Enclosure 1
Marked-Up TS and Bases Pages Reflecting Extended DG AOT

Vogtle Units 1 and 2

Enclosure 2
Evaluation of Risk Impact Due to Extended DG AOT

Enclosure 3
Miscellaneous Editorial Corrections

Table 5.5.9-2 (page 1 of 1)
Steam Generator Tube Inspection

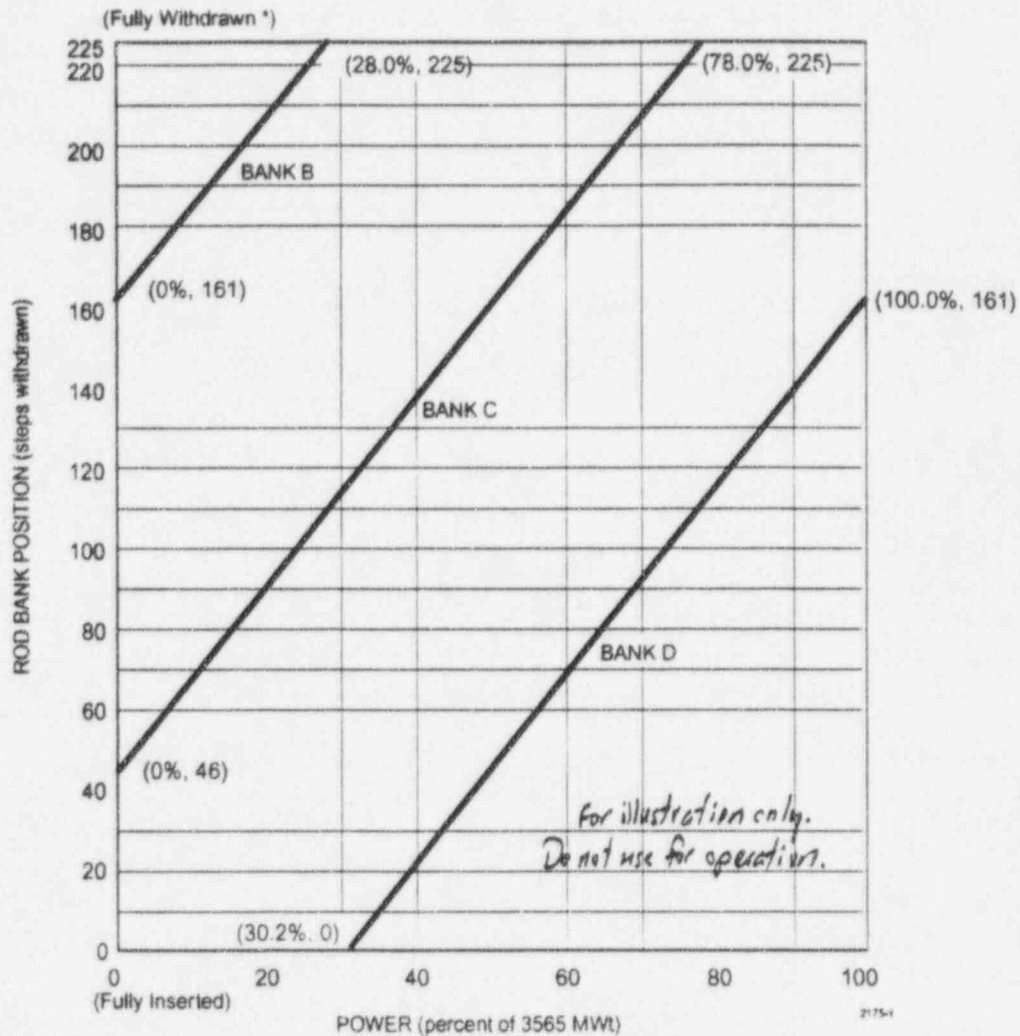
font should be consistent
with remainder of page
